FARRAGUT MUNICIPAL PLANNING COMMISSION AGENDA

September 17, 2020

REPORT TO THE FARRAGUT MUNICIPAL PLANNING COMMISSION

Thank you for your comments regarding the Brookmere Phase 3 Preliminary Plat. Please find attached to this digital submittal the revised plans and attachments. Additionally, each comment agreed upon is addressed below in **bold**.

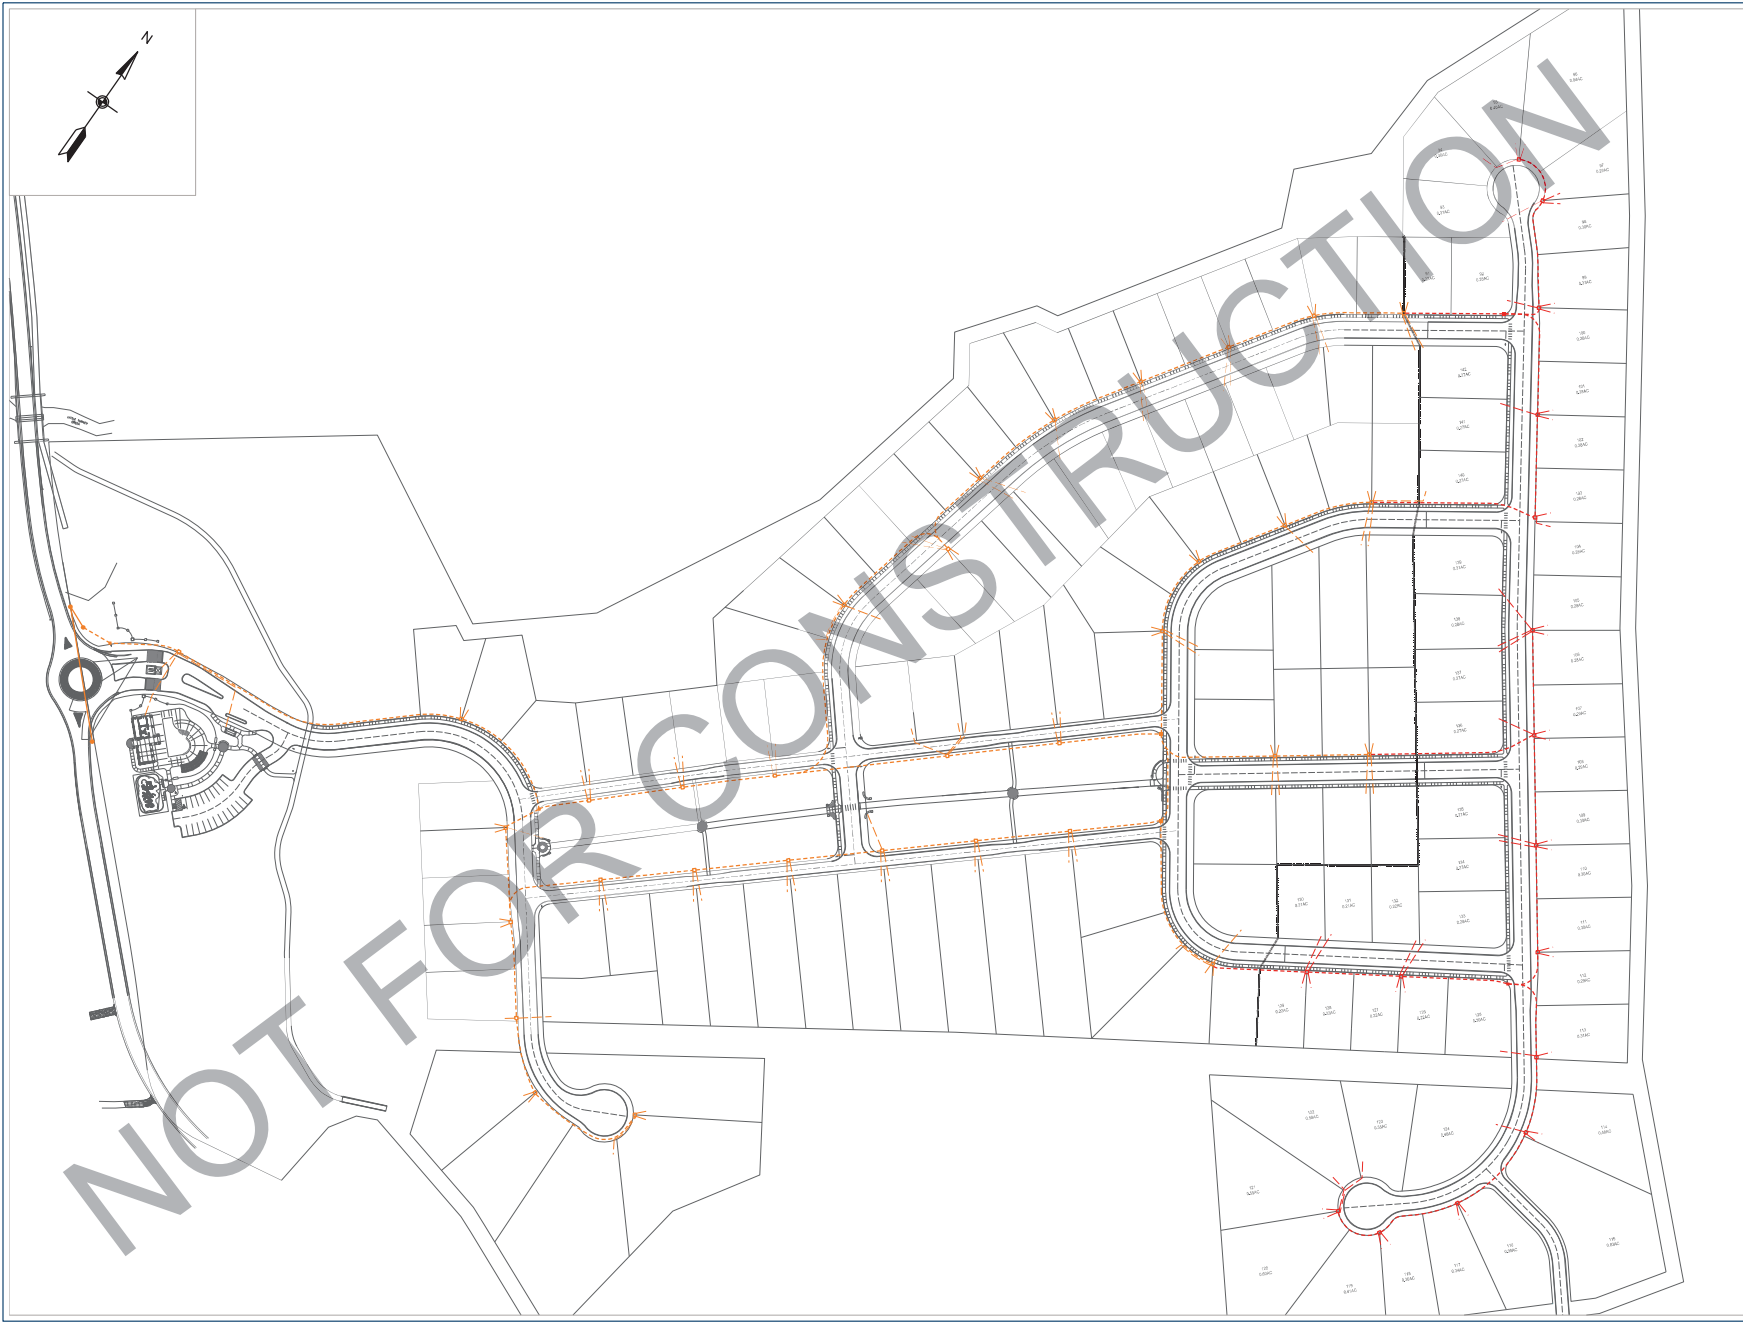
- 7) Please include a cross section for the connector road. It must be constructed to local street standards since it will be a public street. - **The cross section has been included on C401.**
